Addendum No. 01

SUBJECT: OR22: Center St Bridge (Phase 1) Project
Willamina-Salem Highway
Marion & Polk Counties
Grading, Drainage, Structures, Paving, Signing, Illumination, And Roadside
Development
(Bids Closing September 22, 2026)

CONTRACT NO.: 15659 **PROJECT:** OR22: CENTER ST BRIDGE (PHASE 1)
PROJECT KEY: 21705 **ADDENDUM NO.:** 1

SHEET NO.
JB01

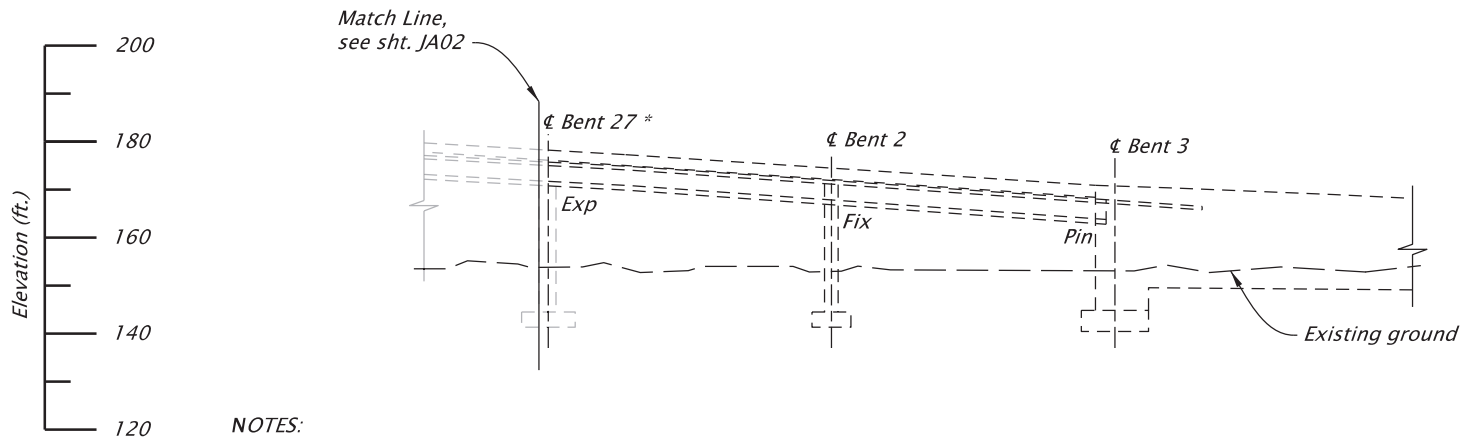
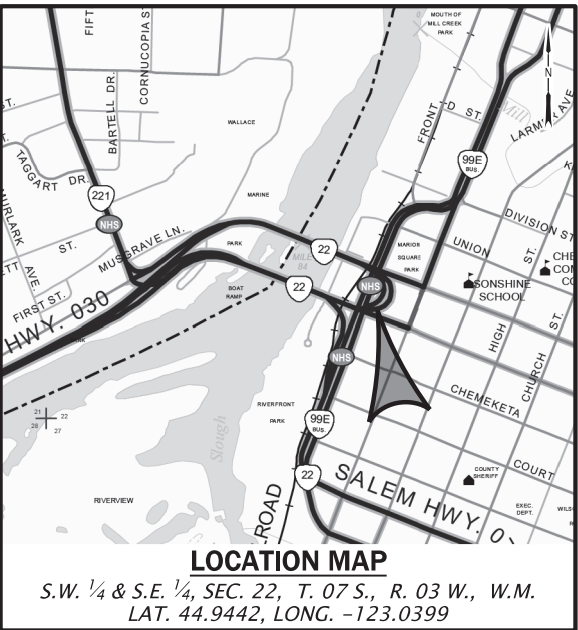
No.	DATE	REVISIONS	BY
	08-18-26	Addendum No. 1, added sign mounts, revised accompanied by and informational DWG. No.'s	N.L.F.

- 63 Remove extg. asphaltic plug joint seal and replace with a new asphaltic plug joint seal, see dwg. BR157 for details.
- 84 Install chevron sign mount, see sht. JB03 for details.
- 86 Core vertically through superstructure and install stainless steel smooth dowel bar, see sht. JB02 for details.
- 90 Bridge deck cold plane pavement removal, 3-4" deep and bonded membrane removal. Install rolled waterproofing membrane and Level 3, 1/2" ACP wearing course, see sht. JB02 for details.
- 91 Bridge approach slab cold plane pavement removal, 3-4" deep and bonded membrane removal. Install rolled waterproofing membrane and Level 3, 1/2" ACP wearing course, see sht. JB02 for details.

SHEET NO.
JC01

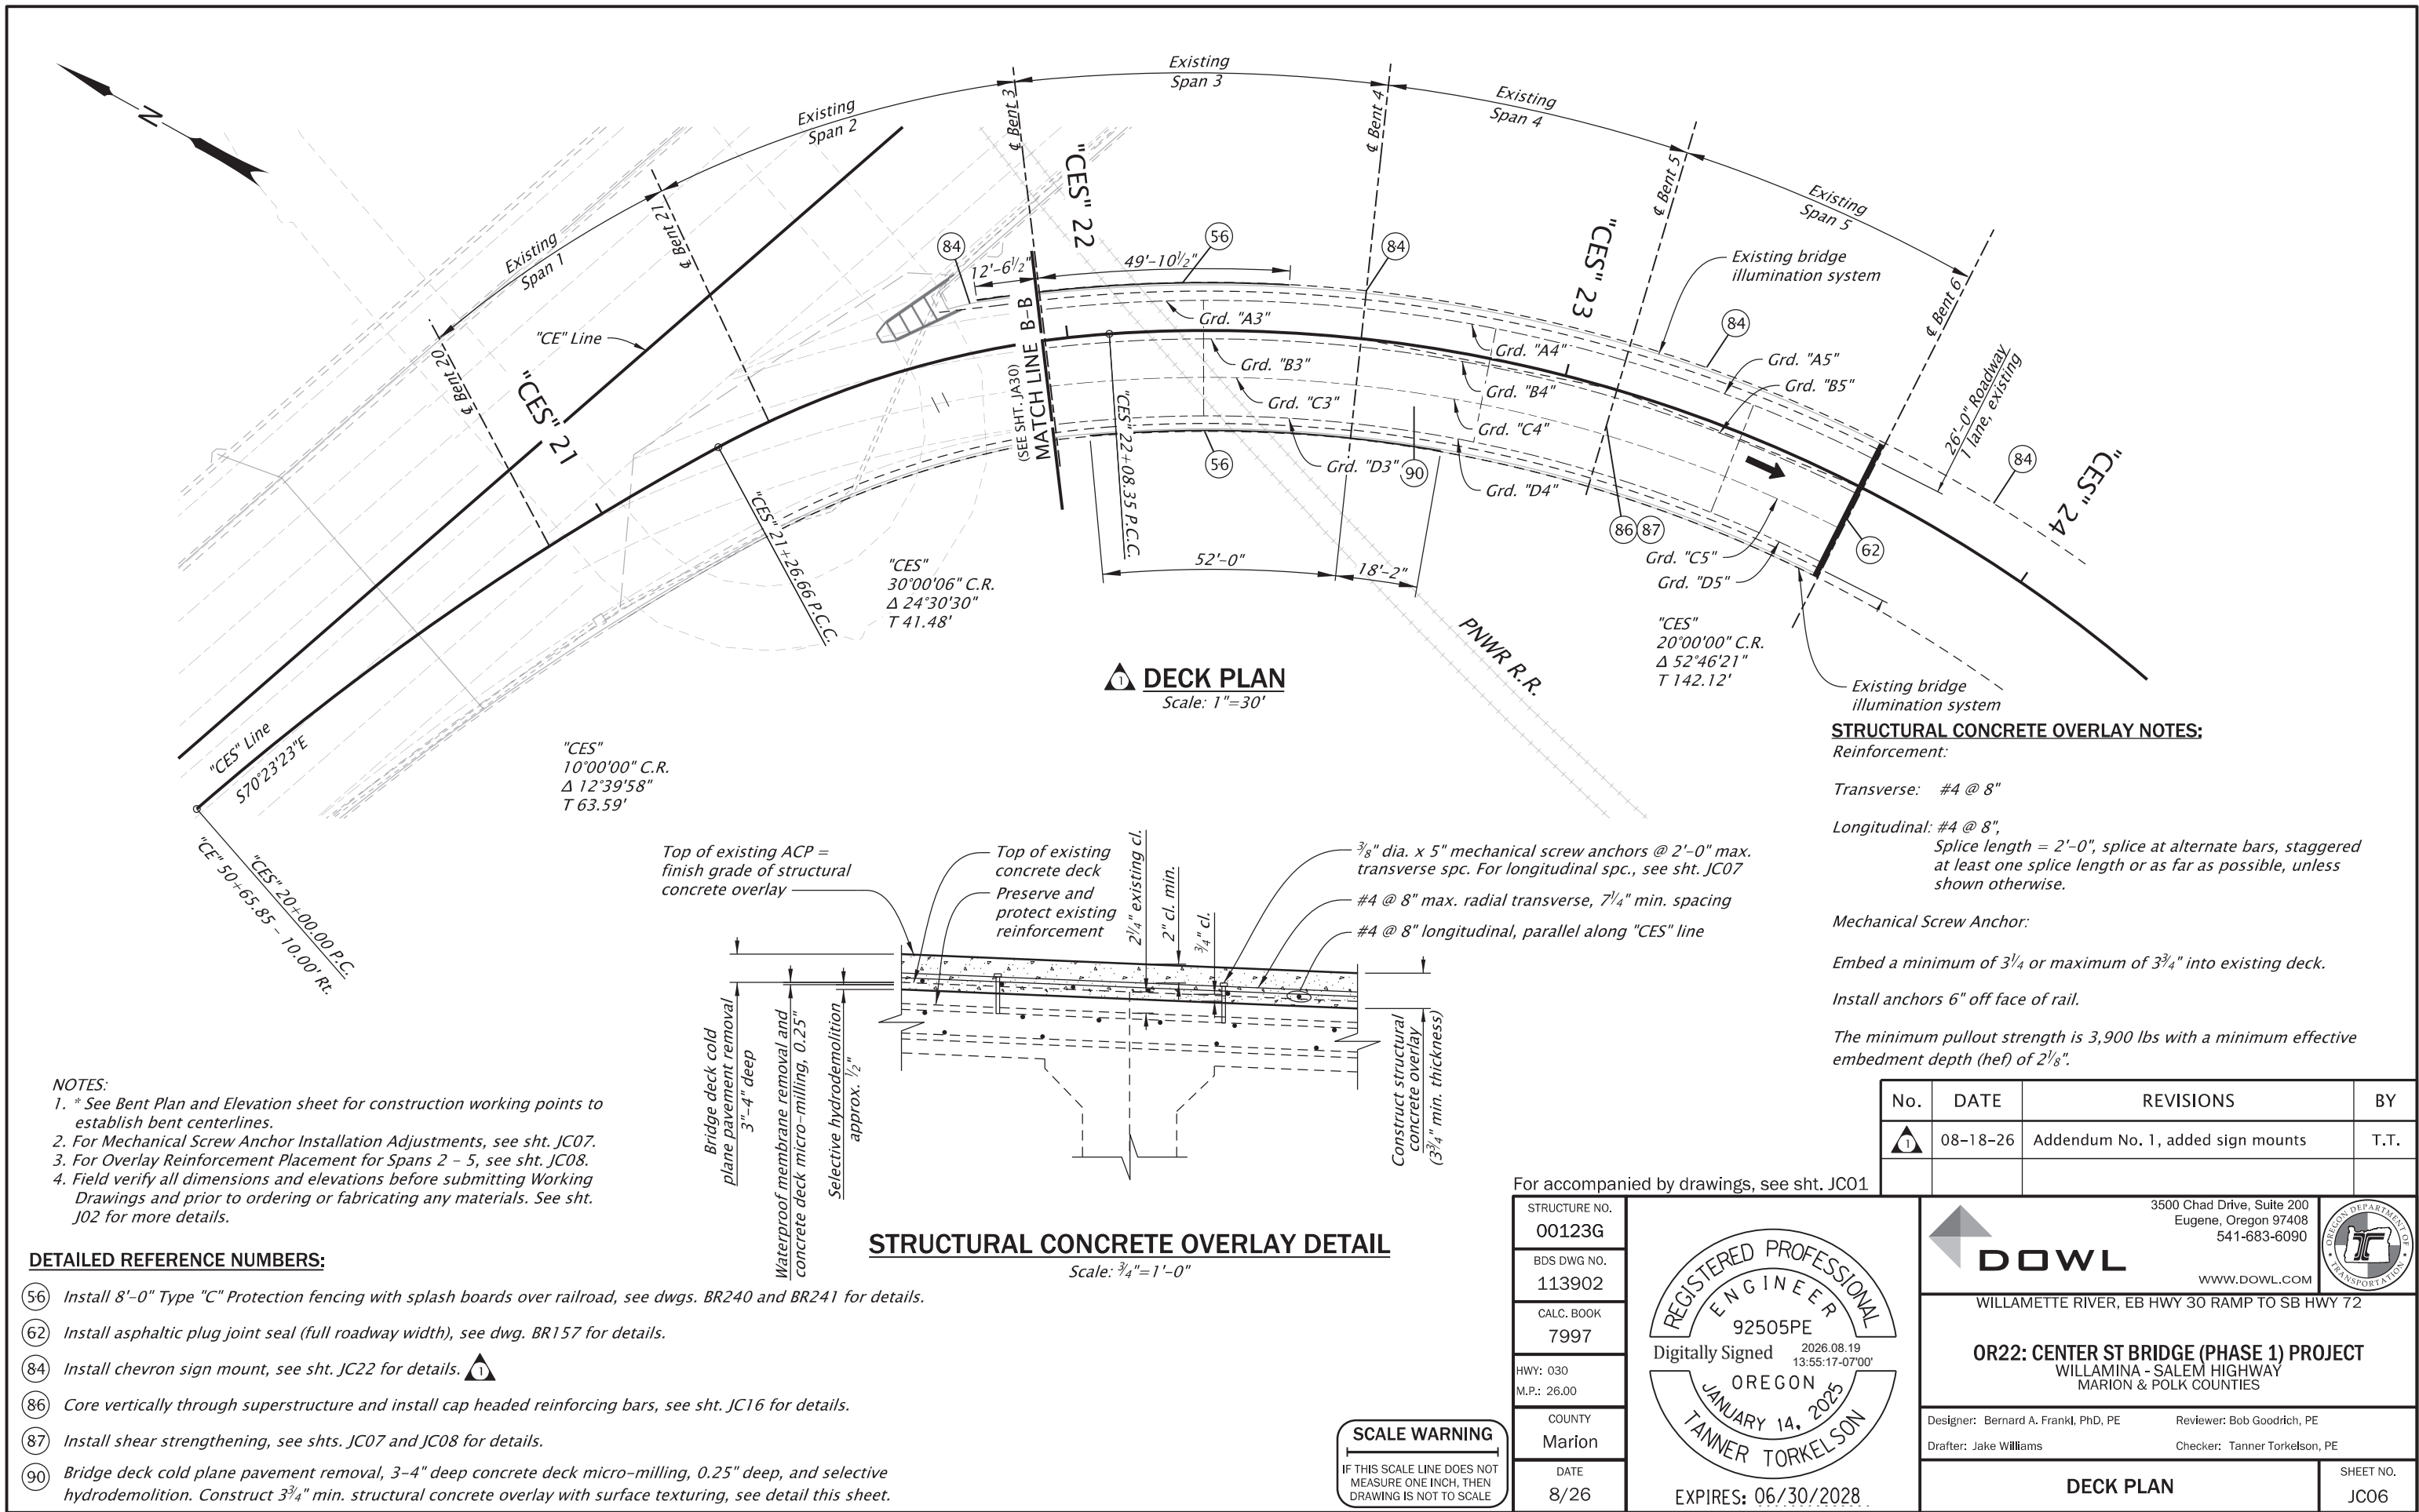
No.	DATE	REVISIONS	BY
1	08-18-26	Addendum No. 1, added sign mounts	T.T.

SHEET NO.
① JB03

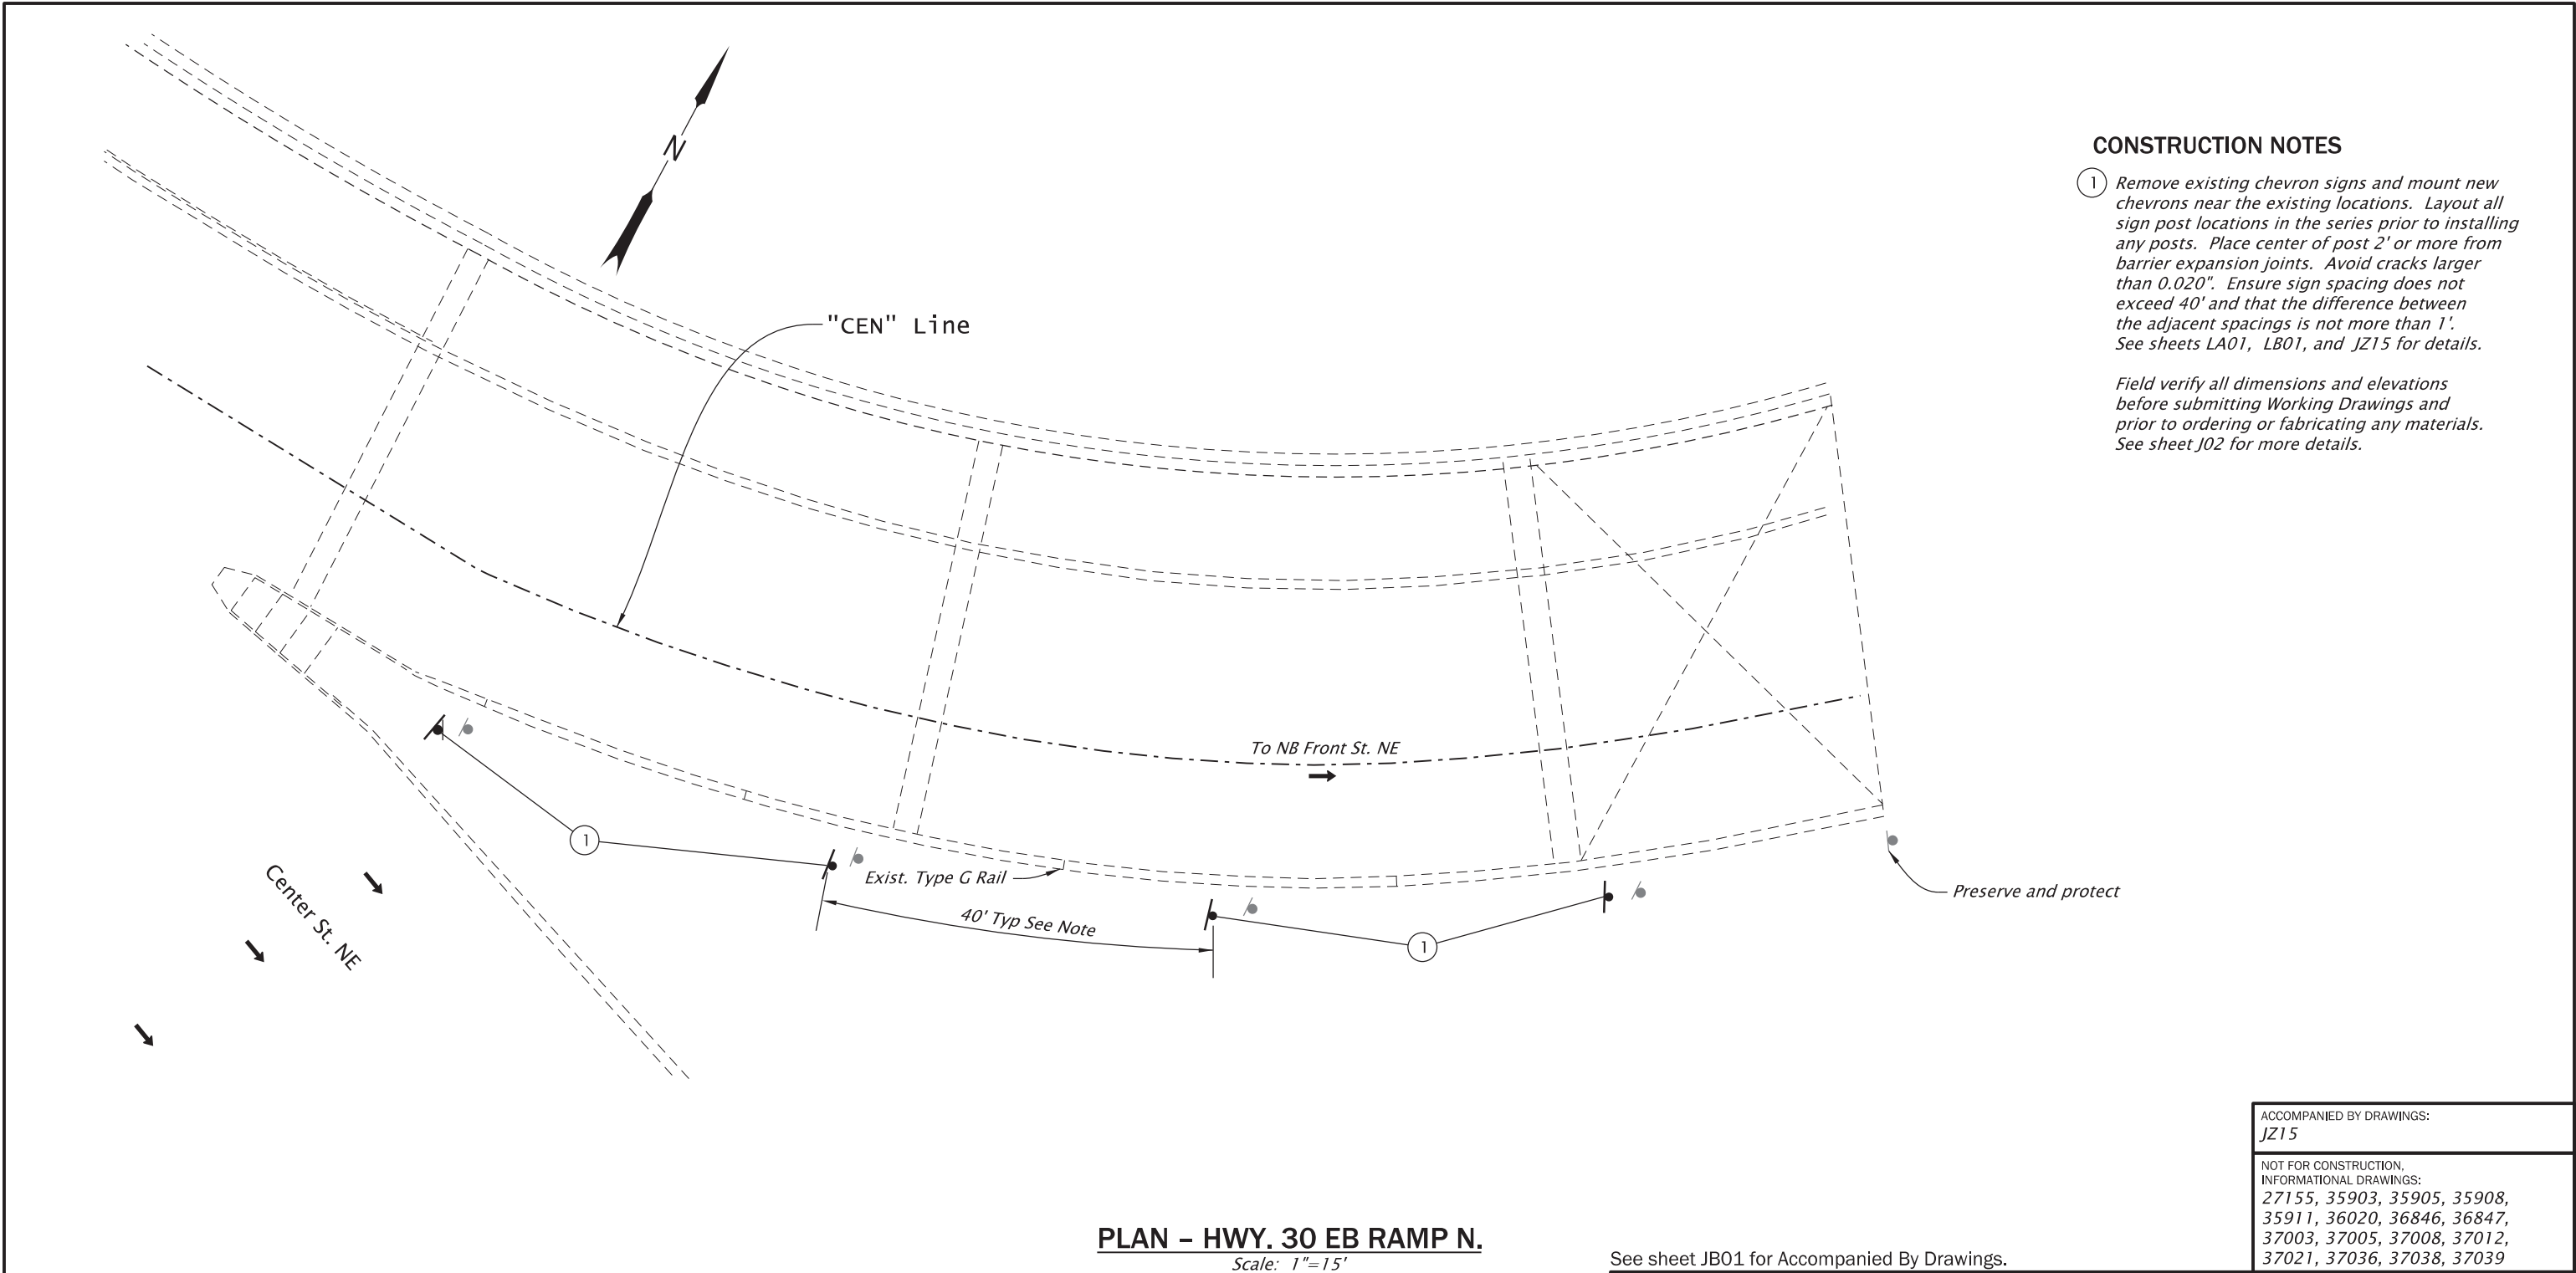
- ① Remove existing chevron signs and mount new chevrons near the existing locations. Layout all sign post locations in the series prior to installing any posts. Place center of post 2' or more from barrier expansion joints. Avoid cracks larger than 0.020". Ensure sign spacing does not exceed 40' and that the difference between the adjacent spacings is not more than 1'. See sheets LA01, LB01, and JZ15 for details.

No.	DATE	REVISIONS	BY
①	08-17-26	Addendum 01 (sheet added)	JEKP

SHEET NO.
1 JC22

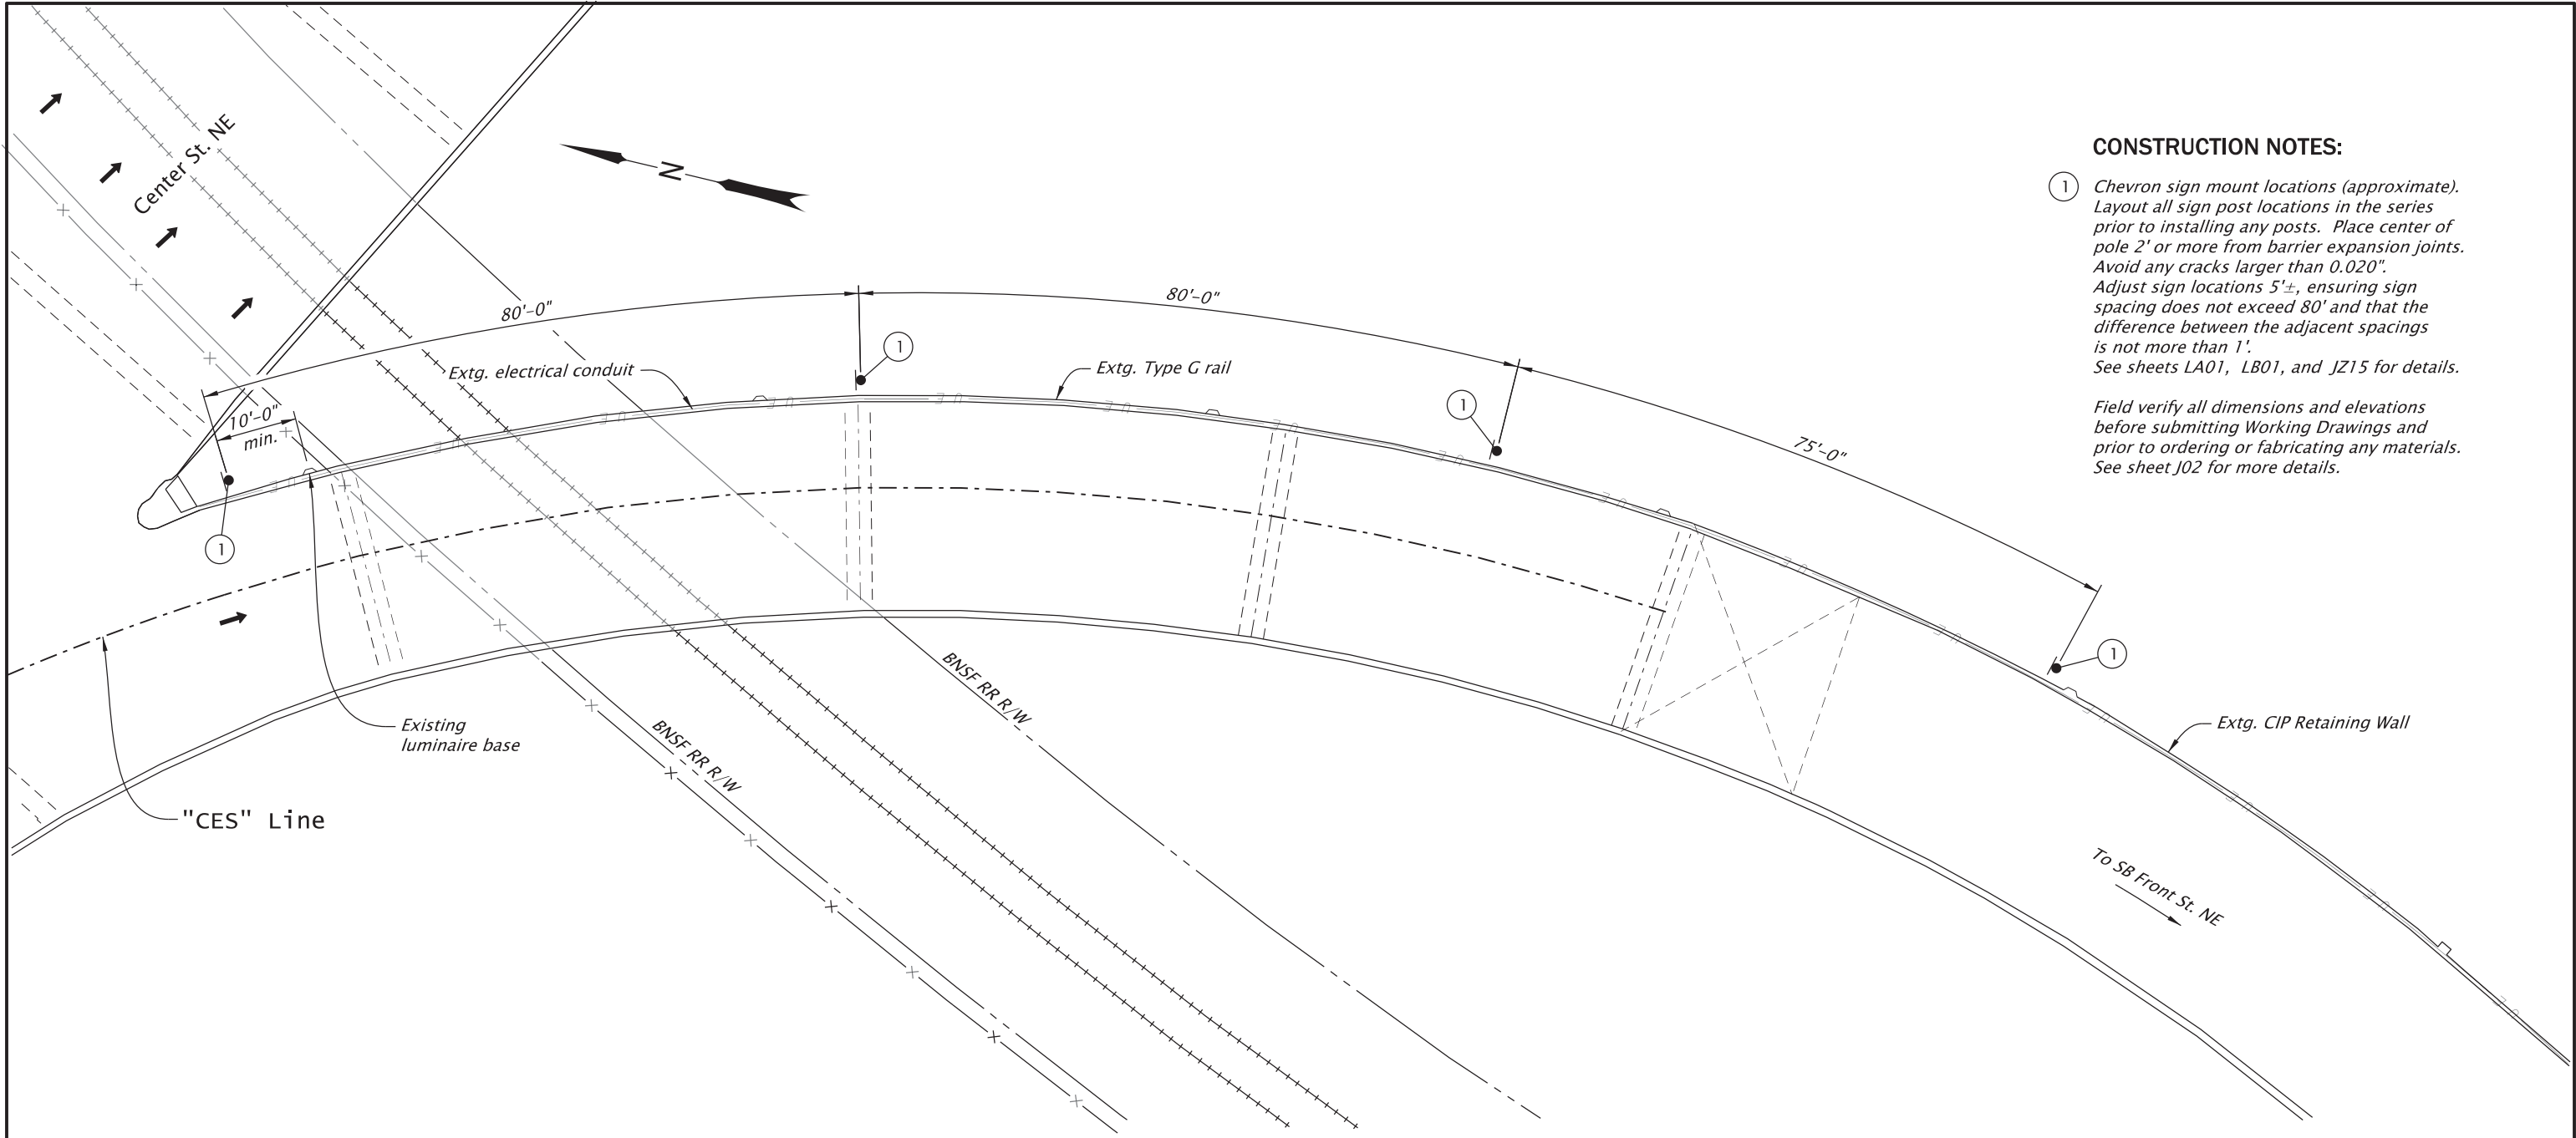
- ① Chevron sign mount locations (approximate). Layout all sign post locations in the series prior to installing any posts. Place center of pole 2' or more from barrier expansion joints. Avoid any cracks larger than 0.020". Adjust sign locations 5'±, ensuring sign spacing does not exceed 80' and that the difference between the adjacent spacings is not more than 1'. See sheets LA01, LB01, and JZ15 for details.
- Field verify all dimensions and elevations before submitting Working Drawings and prior to ordering or fabricating any materials. See sheet J02 for more details.

No.	DATE	REVISIONS	BY
1	08-17-26	Addendum 01 (sheet added)	JEKP
